ACCESSIBILITY CHECKLIST

DEPARTMENT OF REHABILITION

4930 W KAWEAH COURT SUITE 100 VISALIA, CA 93277

RESD PROJECT #139602

(IR2) DEPARTMENT OF REHABILITATION RECEPTION AREA

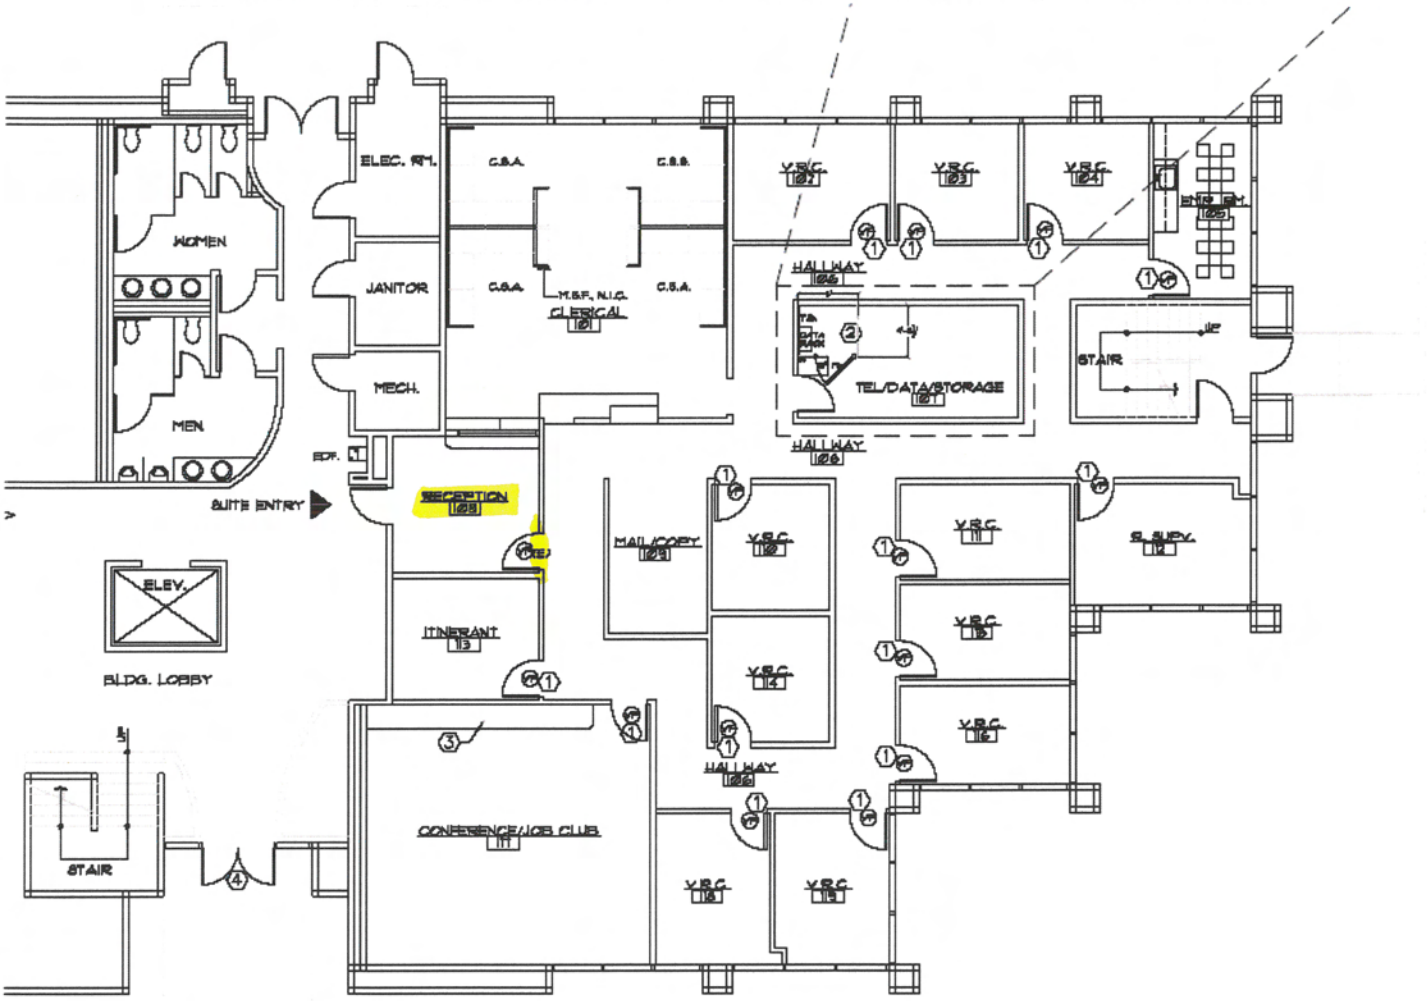
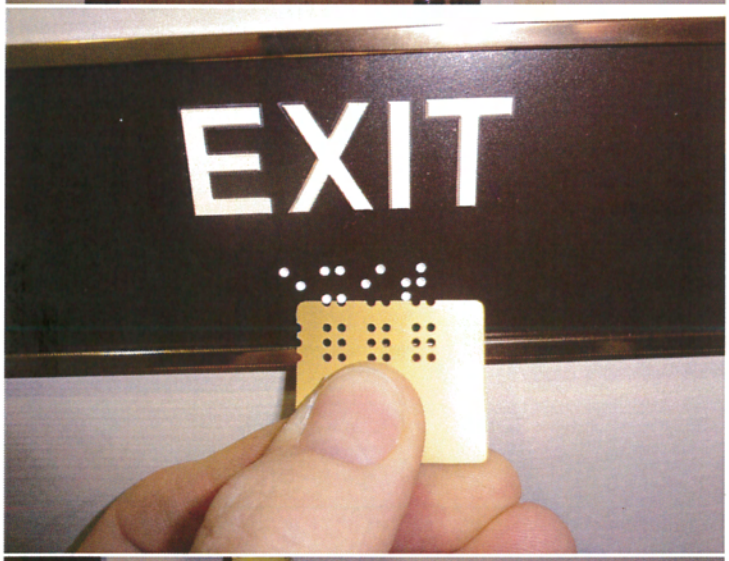
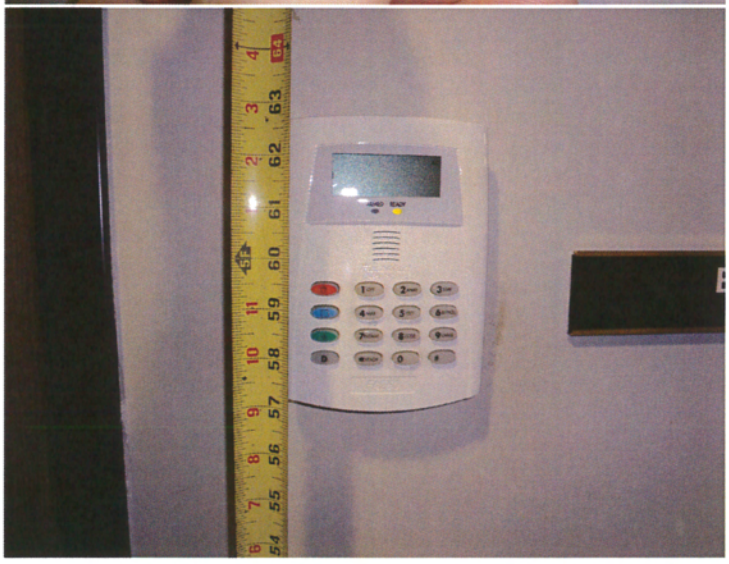
12.2B	Directional and Informational Signs	Do signs which provide direction to, or information about, functional spaces of the building comply with the requirement for visual signage? EXCEPTION: Building directories, menus, and all other signs which are temporary are not required to comply. 11B-216.3, 11B-703.5	SUITE 100 SIGNS DO NOT MEET THE REQUIREMENTS		Yes ☐ No ■ N/A ☐

12.4B	Mounting Location	Are tactile signs mounted on the wall adjacent to the latch side of the door 48" min from baseline of lowest Braille to 60" max AFF from baseline of highest line of raised characters? For double doors with one active leaf, is the sign located on the inactive leaf? For double doors with both active leafs, is the sign located to the right of the right hand door? If there is no wall space, is the sign located at the latch side of a single door or at the right side of double door on the nearest adjacent wall? 11B-703.4.1 Figure 11B-703.4.1, 11B-703.4.2			Yes ☐ No ■ N/A ☐

(IR3) DEPARTMENT OF REHABILITATION HALLWAYS

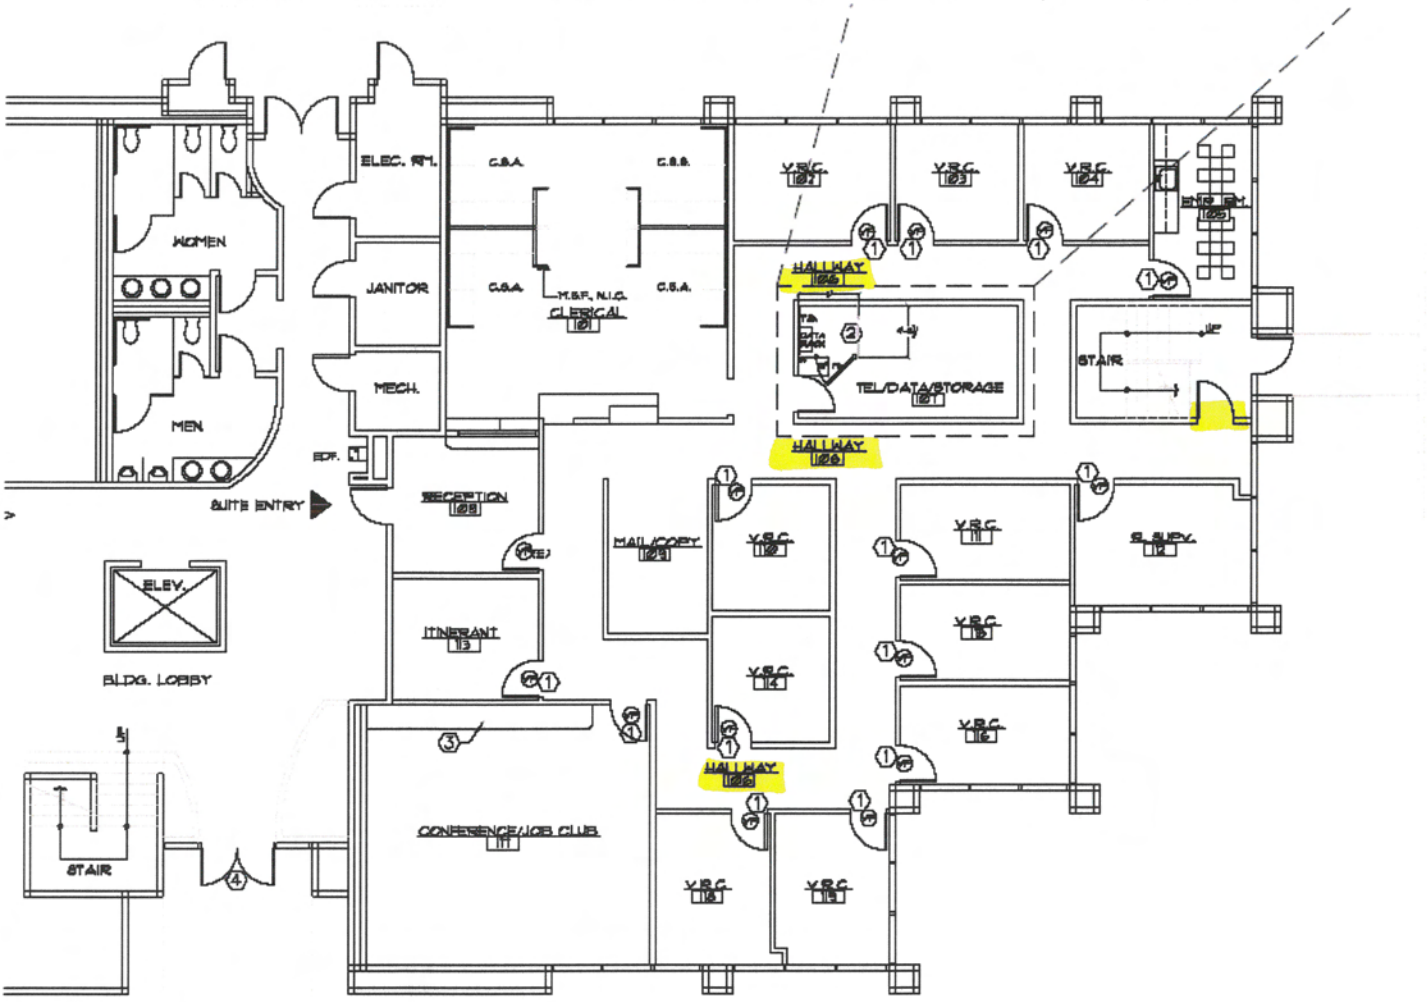
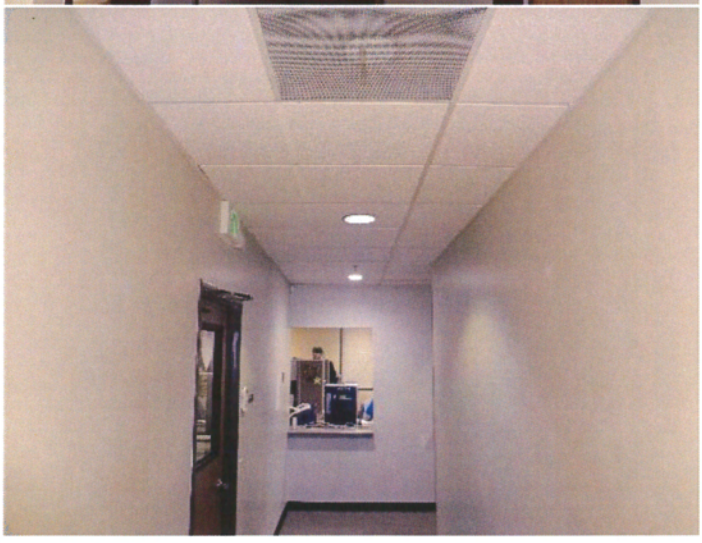
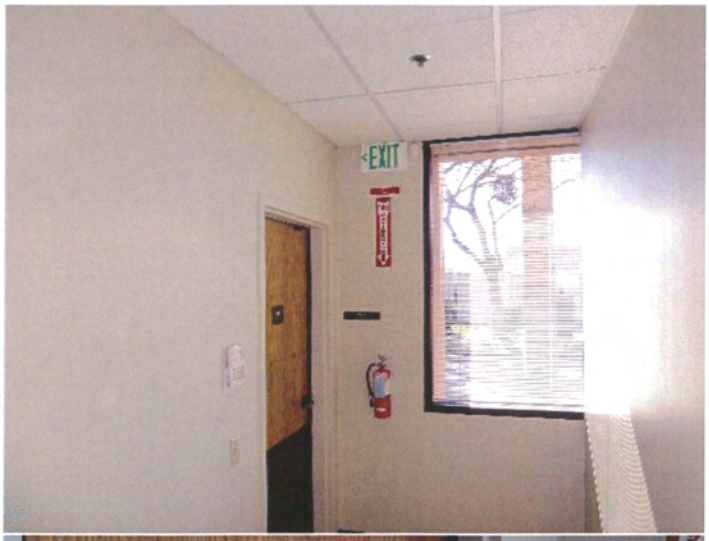
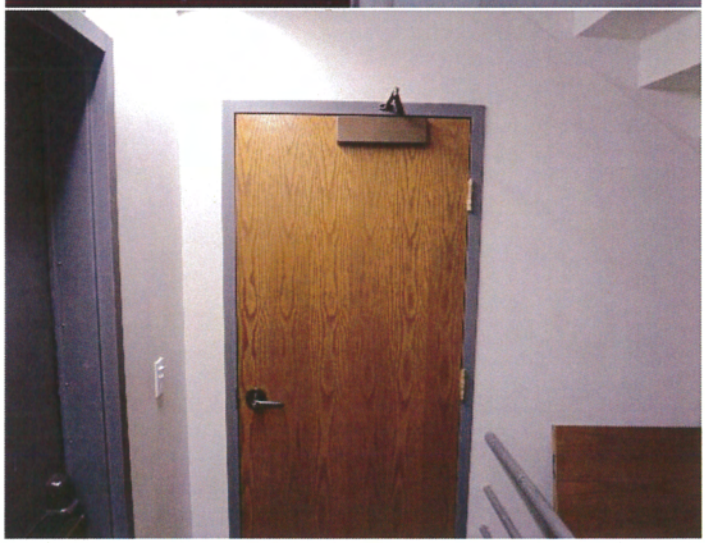
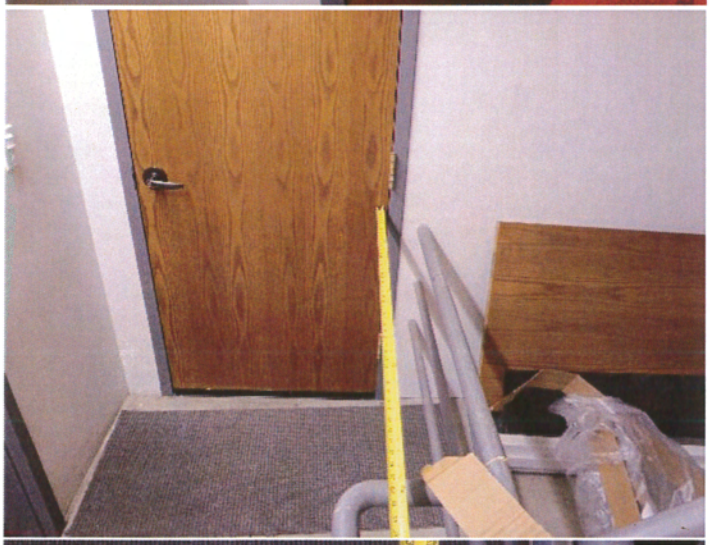
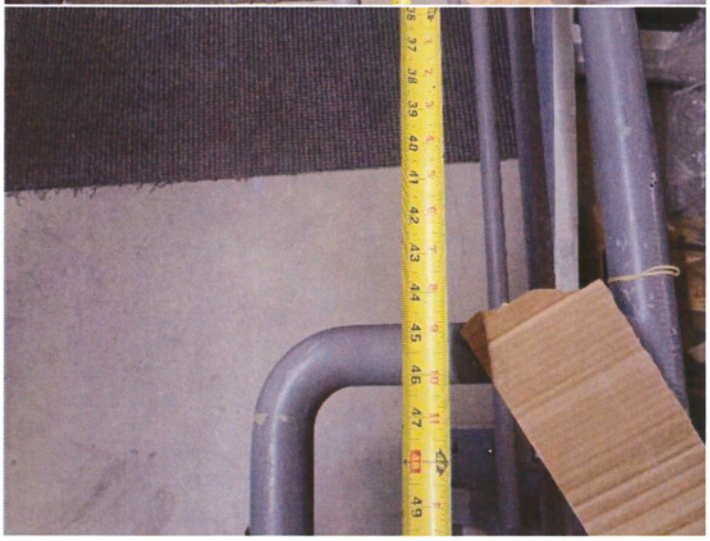
12.10A	Other Door Requirements	Does the door comply with all applicable requirements of Survey Form 11 - Doors and Gates? If not, check the "No" field and enter all non-complying item numbers in the comment field (to the right of this box). This will eliminate the need to fill out Form 11 for this interior accessible route. 11B-206.4	11.6 11.25 11.11 11.27 11.13 11.14 11.23		Yes ☐ No ■ N/A ☐

12.11A	Directional and Informational Signs	Do signs which provide direction to, or information about, functional spaces of the building interior and exterior comply with the requirement for visual signage? EXCEPTION: Building directories, menus, and all other signs which are temporary are not required to comply. 11B-216.3, 11B.703.5			Yes ☐ No ■ N/A ☐

12.23A	Other Identification Signage Requirements	Does the sign comply with all applicable requirements of Survey Form 19 - Signage? If not, check the "No" field and enter all non-complying item numbers in the comment field (to the right of this box). This will eliminate the need to fill out Form 11 for this entrance. 11B-703	19.1 19.5 19.9 19.12 19.14		Yes ☐ No ■ N/A ☐

(TR1) MEN'S RESTROOM

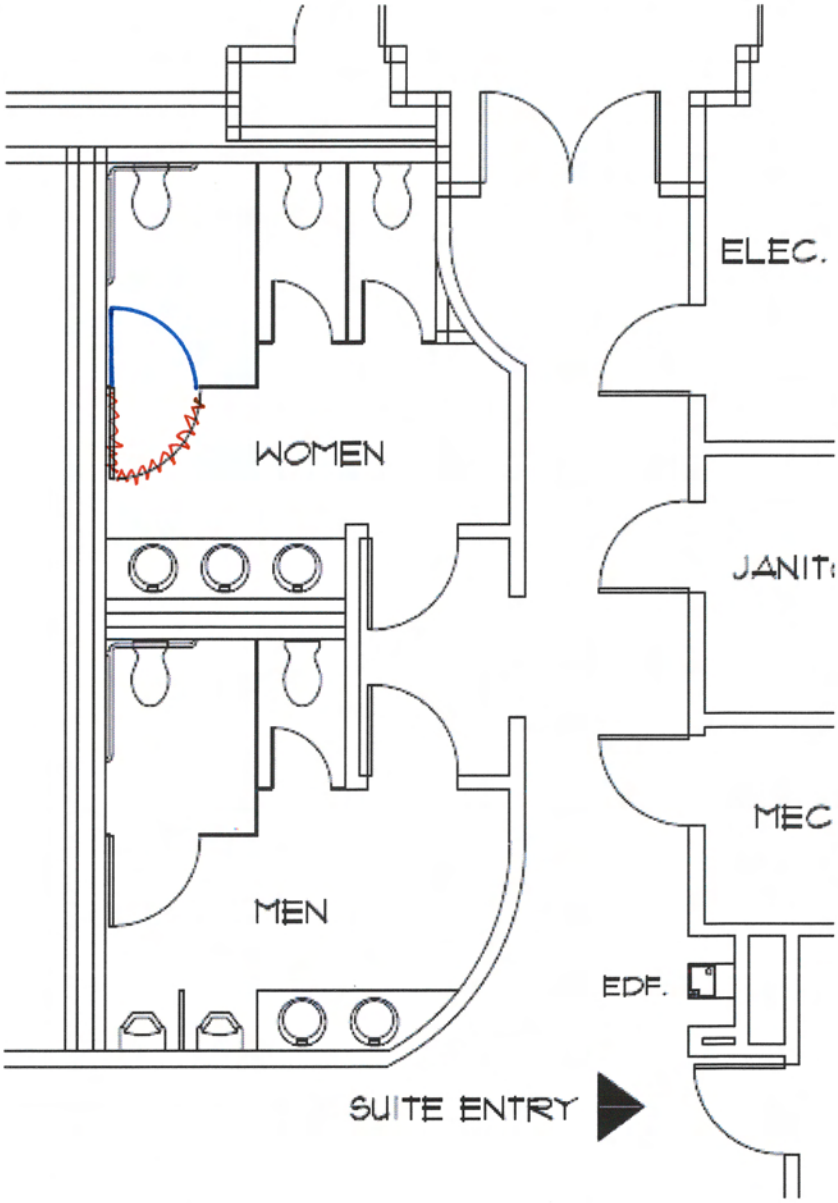
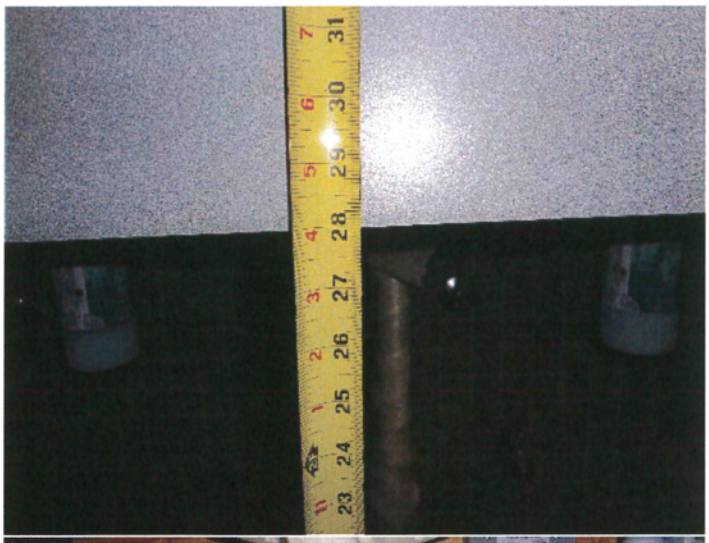
16.12	Other Door Requirements	Does the door comply with all applicable requirements of Survey Form 11 - Doors and Gates? If not, check the "No" field and enter all non-complying item numbers in the comment field (to the right of this box). This will eliminate the need to fill out Form 11 for this interior accessible route. 11B-206.5, 11B-404.1	11.6 11.13 11.19 11.26 11.27		Yes ☐ No ■ N/A ☐

16.55	Rear Grab Bar	Does the rear grab bar extend from the centerline of the WC 12" min. on one side and 24" min. on the other side? 11B-604.5.2, Figure 11B-604.5.2			Yes ☐ No ■ N/A ☐

16.58	Urinals	Where urinals are provided, does at least one comply with the requirements below? 11B-605			Yes ☐ No ■ N/A ☐
16.59	Urinal Rim Height	Does the urinal have an elongated rim projecting at least 13 1/2" from the wall and a maximum of 17" AFF? 11B-605.2, Figure 11-B-605.2			Yes ■ No ☐ N/A ☐

16.66	Lavatory Knee Clearance	Is there space below the lavatory 27"high minimum AFF at a depth of 8" minimum increasing to 29" high minimum at the front edge of the counter or the front edge of the wall-mounted lavatory? Between 9" and 27" AFF, the knee clearance can be reduced at a rate of 1" in depth for each 6" in height. 11B-306.3.3 exception 1, 11B-306.3.4, Figure 11B-306.3	28" @ FRONT EDGE OF COUNTER		Yes ☐ No ■ N/A ☐

(TR2) WOMEN'S RESTROOM

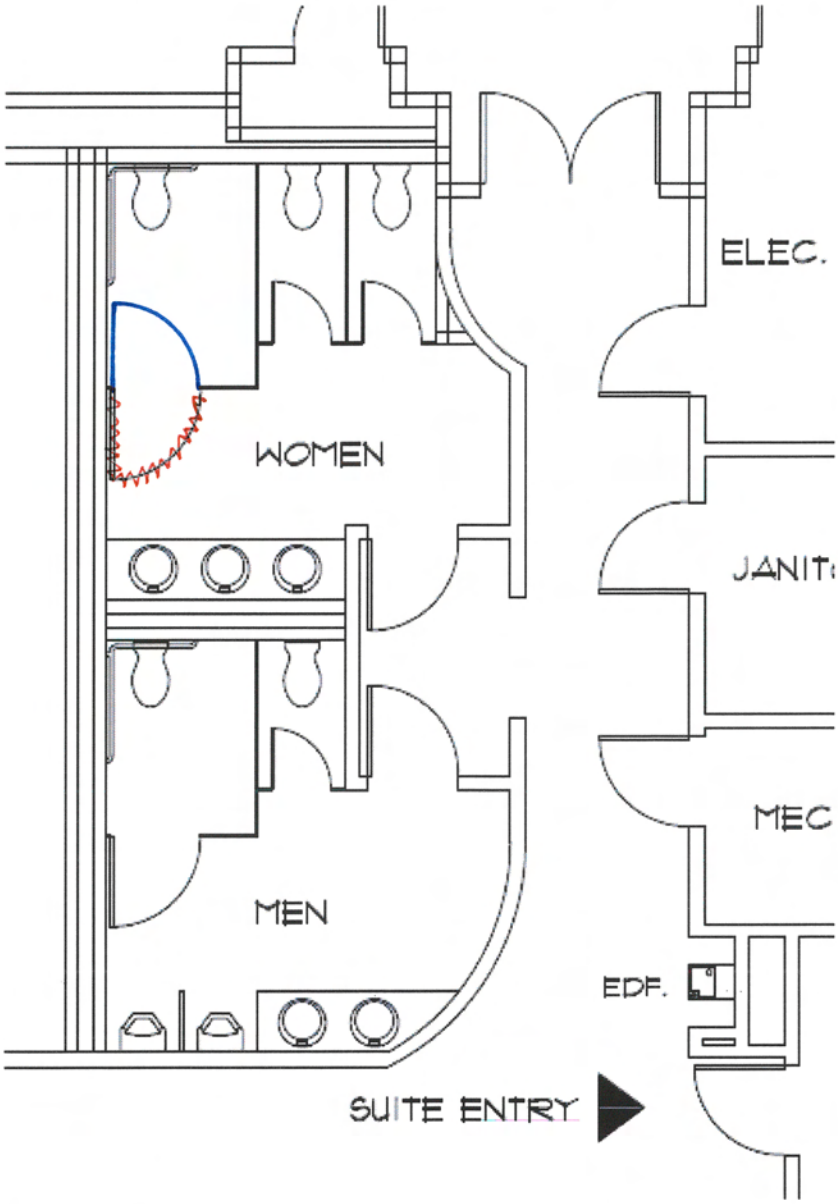
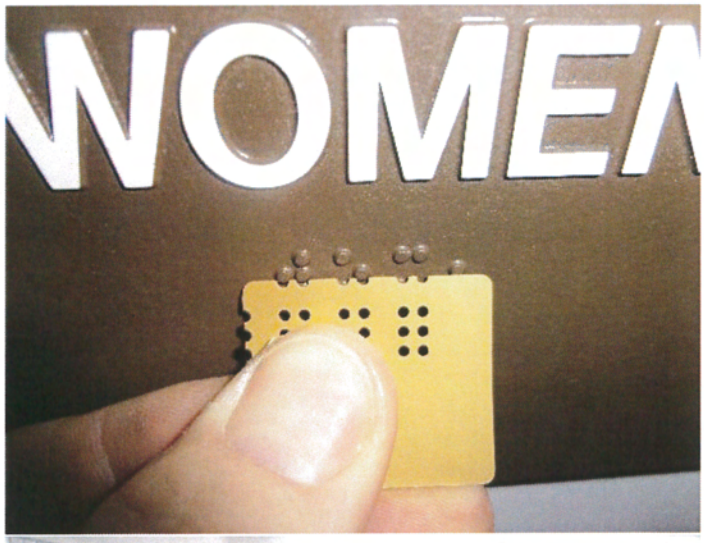
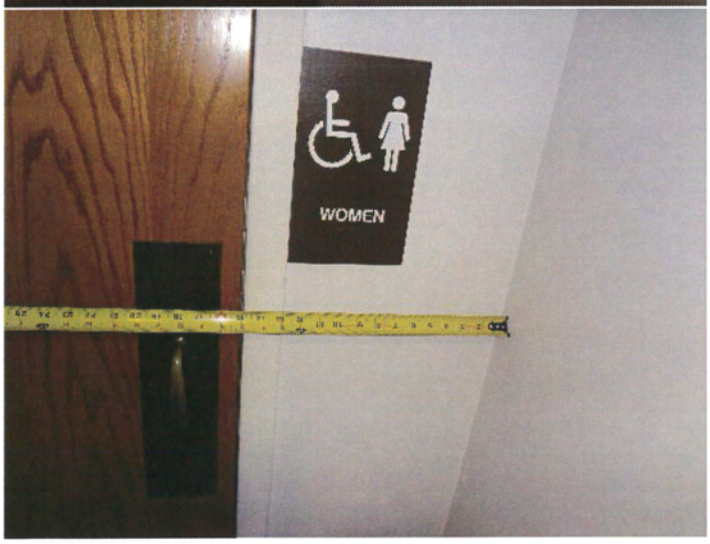
16.38	Stall Maneuvering Space	If the stall has an end entry stall door, is there at least a 60" wide by 48" deep clear floor space in front of the WC? 11B-604.8.1.1.3, Figure 11B-604.8.1.1.3	STALL NOT 60" WIDE		Yes ☐ No ■ N/A ☐

16.66	Lavatory Knee Clearance	Is there space below the lavatory 27"high minimum AFF at a depth of 8" minimum increasing to 29" high minimum at the front edge of the counter or the front edge of the wall-mounted lavatory? Between 9" and 27" AFF, the knee clearance can be reduced at a rate of 1" in depth for each 6" in height. 11B-306.3.3 exception 1, 11B-306.3.4, Figure 11B-306.3	27 13/16" @ FRONT EDGE OF COUNTER		Yes ☐ No ■ N/A ☐
